To: City of Phoenix Planning Commission **Date:** October 31, 2025

Subject: ITEM NO. 10 (Z-103-25-8) – APPROXIMATELY 570 FEET WEST OF
THE NORTHWEST CORNER OF 27TH AVENUE AND BASELINE ROAD

Rezoning Case No. Z-103-25-8 is a request to rezone 1.89 acres located approximately 570 feet west of the northwest corner of 27th Avenue and Baseline Road from S-1 (Ranch or Farm Residence) to C-2 (Intermediate Commercial) to allow for commercial uses - a bank and restaurant.

Elevations date stamped October 20, 2025 (2 pages)

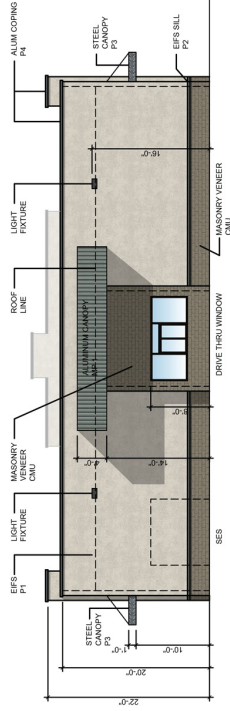
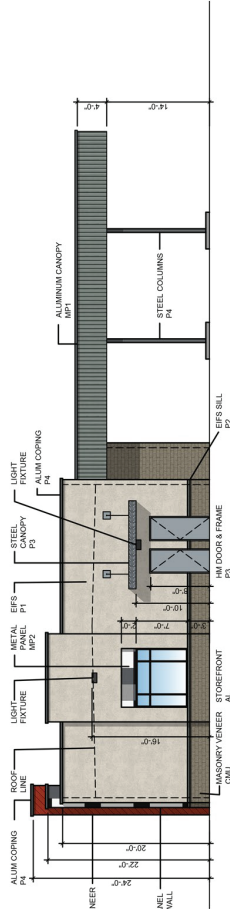
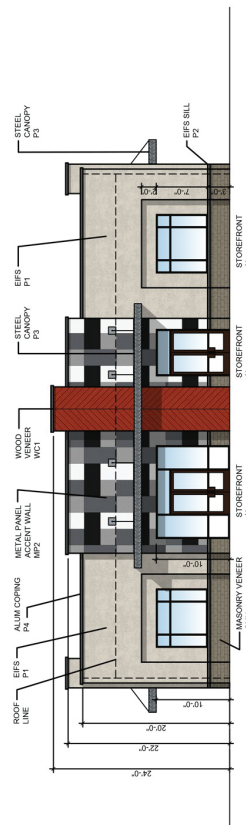
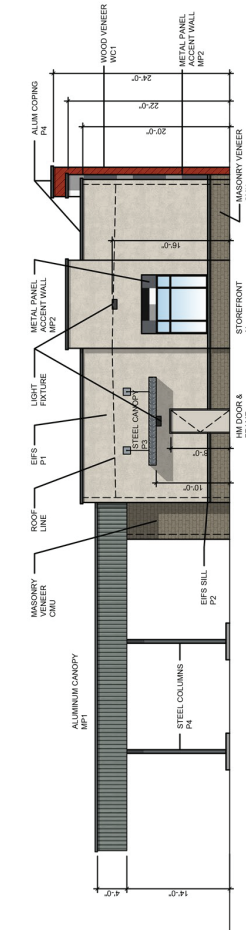
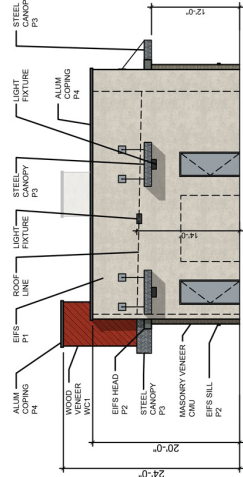
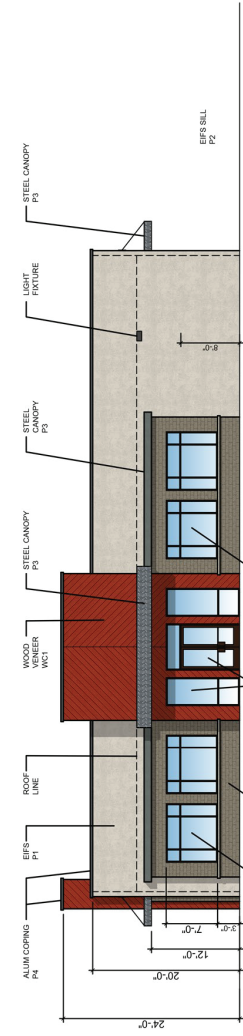
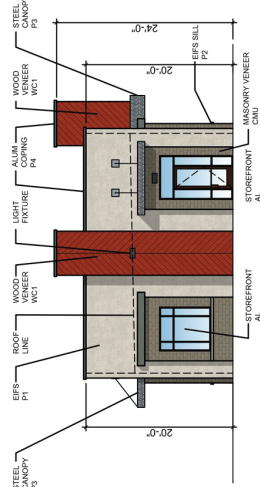
The applicant presented revised elevations during the VPC meeting (attached). That is reflected in Stipulation No. 2. Staff has no concerns with the modified language of Stipulation No. 3, requiring a minimum of 25% non-stucco accent materials on perimeter street facing elevations. To ensure compliance, staff recommends modifying the language in Stipulation No. 4 to require the review and comment of the landscape and sign plans prior to preliminary site plan approval.

2. THE DEVELOPMENT SHALL BE IN GENERAL CONFORMANCE WITH THE ELEVATIONS DATE STAMPED OCTOBER 22, 2025, AS MODIFIED BY THE FOLLOWING STIPULATIONS AND APPROVED BY THE PLANNING AND DEVELOPMENT DEPARTMENT.

2. All perimeter street facing building elevations shall contain architectural features that reflect modern agrarian architecture **AND SHALL CONSIST OF A MINIMUM 25% NON-STUCCO ACCENT MATERIAL** including, but not limited to, ~~DETAILING SUCH AS~~ pitched roof elements, variation in window size, overhang canopies and exterior accent materials such as metal, wood, and stone, as approved by the Planning and Development Department.
